From: Detterman, Mark, Env. Health
Sent: Monday, June 30, 2014 3:38 PM
To: 'Yola Bayram'
Cc: Steve Michelson
Subject: RE: RO#151 1700 Jefferson Oakland, CA

Subject: RO#151 1700 Jefferson Oakland, CA

Figure - 4
Proposed Sampling Locations
1700 Jefferson Street,
Oakland, CA

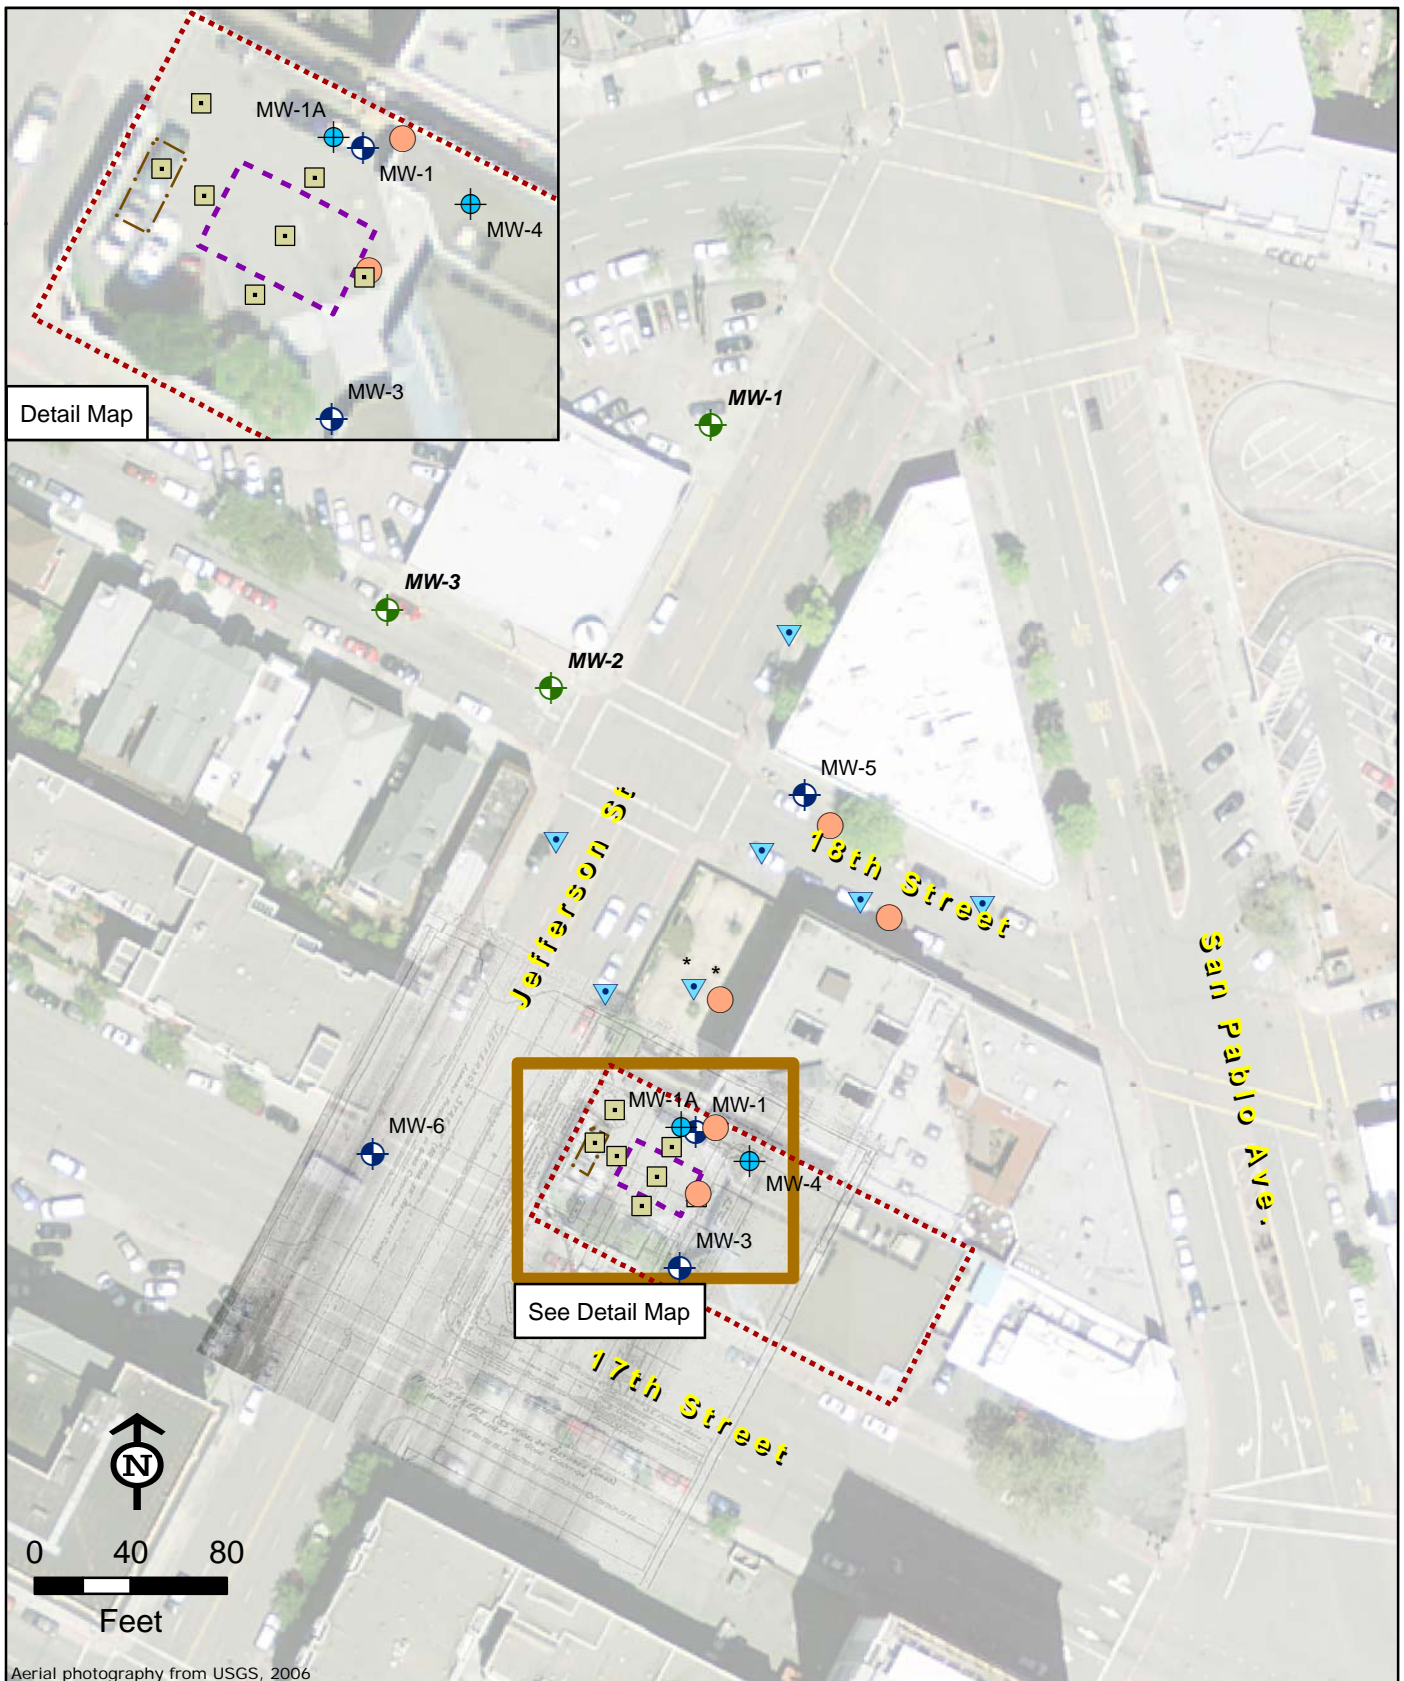
Thanks for the updated site figure. The proposed additional bore is noted. I'm not sure however if it is placed at the same location as the "pit" as the "pit" appears to be pretty close to the northern corner of the lot. I do note that property lines have shifted at the site over time. I ask only that an effort to co-locate the two is made.

I also would highly encourage and recommend that you to install the vapor wells as "permanent" features as discussed in the directive letter. That was my intent in the letter. The locations appear appropriate to gather good data on vapor risk at the site and vicinity. If additional vapor wells are deemed necessary, they can be proposed and installed based on this information. Repeat data is likely essential at this particular site, and these locations will already be installed, rather than waiting for another work reiteration.

An additional soil boring will be advanced in the area of the pit in the northwestern portion of the property. The revised Figure 4 is attached.
